88 Waterloo Road Macquarie Park

Response to Submissions

Prepared For Cottonwood Development Pty Ltd
Final July 2026

This report has been prepared in response to DPHI feedback in relation to a proposed mixed-use development at 15-21 Cottonwood Crescent Macquarie Park, SSD-94006708.

88 WATERLOO ROAD, MACQUARIE PARK - VISUAL ASSESSMENT
VP11 (PHOTO 5279) : LOOKING EAST FROM ELOUERA RESERVE | EXISTING CONDITIONS 2024-06-07 09:07 AEST

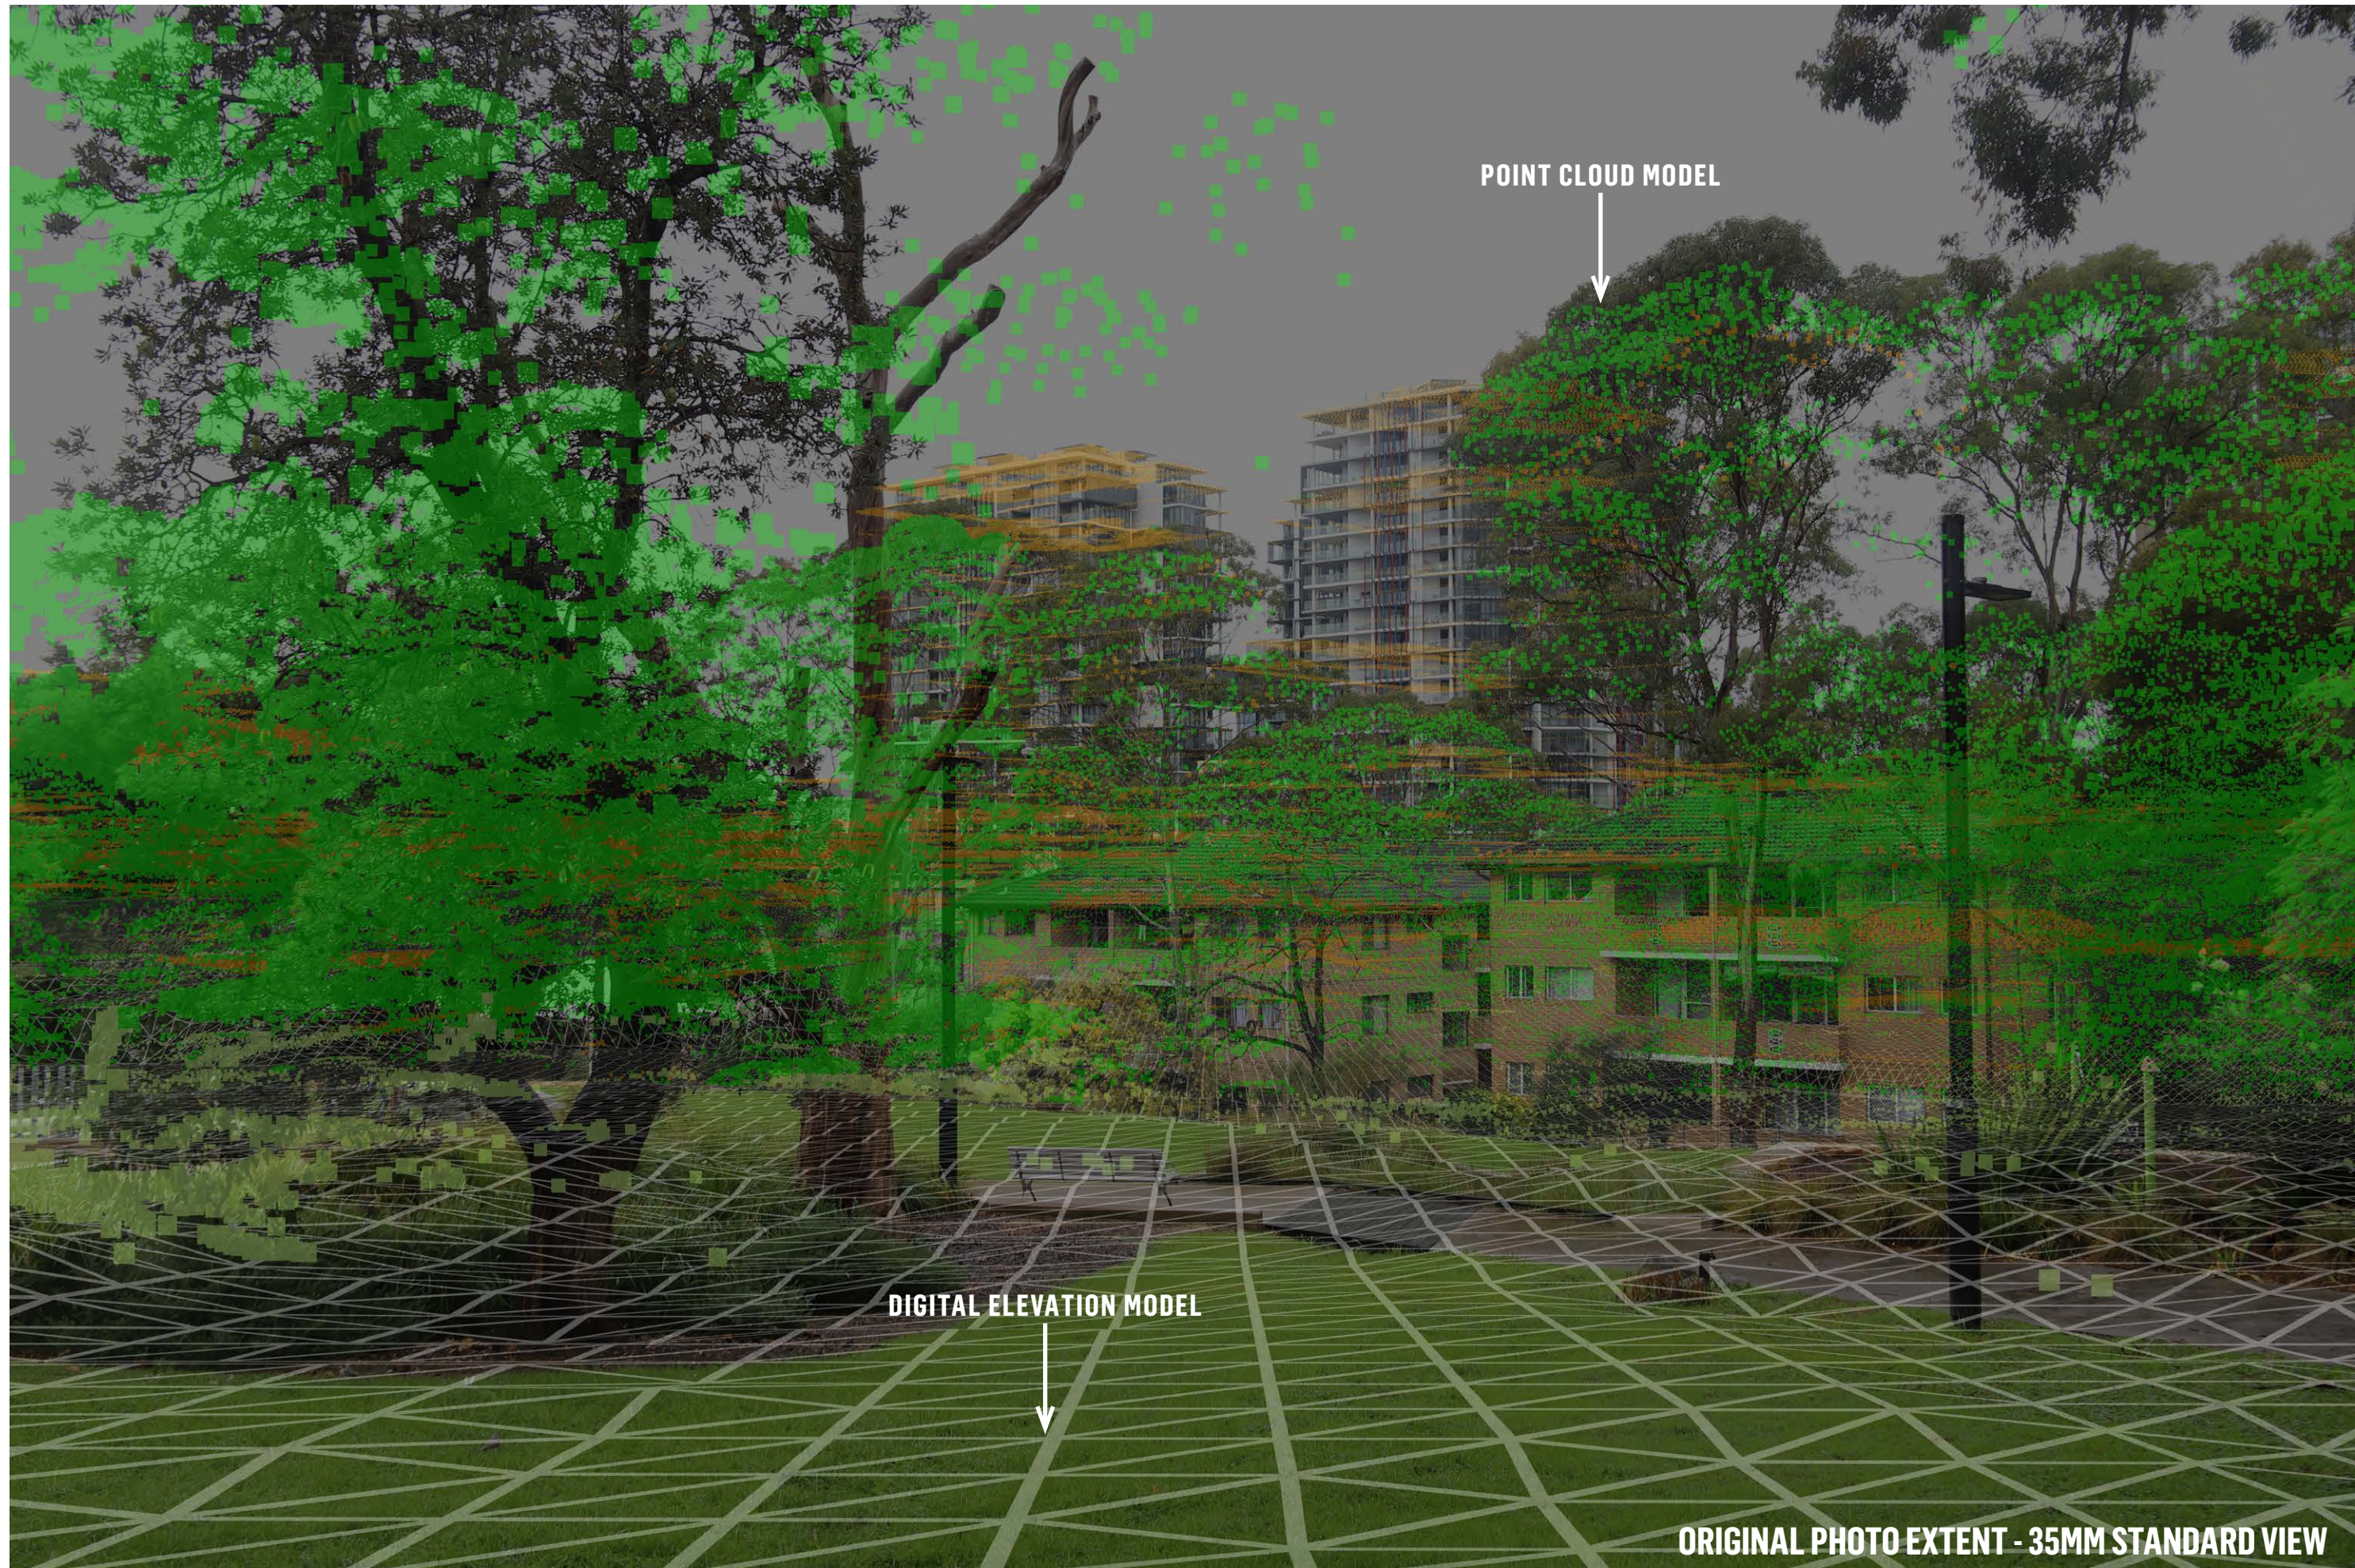
19. The Visual Impact Assessment should be updated to consider the proposal's visual impact when viewed from Elouera Reserve. A photomontage from VP11 within Elouera Reserve must be included.

Urbis have modelled a view from view place 11, as referenced in the January 2026 VIA both without vegetation, and as a fully rendered view with vegetation based on the proposed planting scheme at 5 years maturity to provide a qualitative and quantitative assessment in relation to the potential visual impacts as a result of the proposed development.

The foreground composition of this view is characterised by open areas of grass, vegetation (trees and low height shrubs), a lit pedestrian path and bench seating. The mid-ground composition includes existing development on the site and background tower development further east.
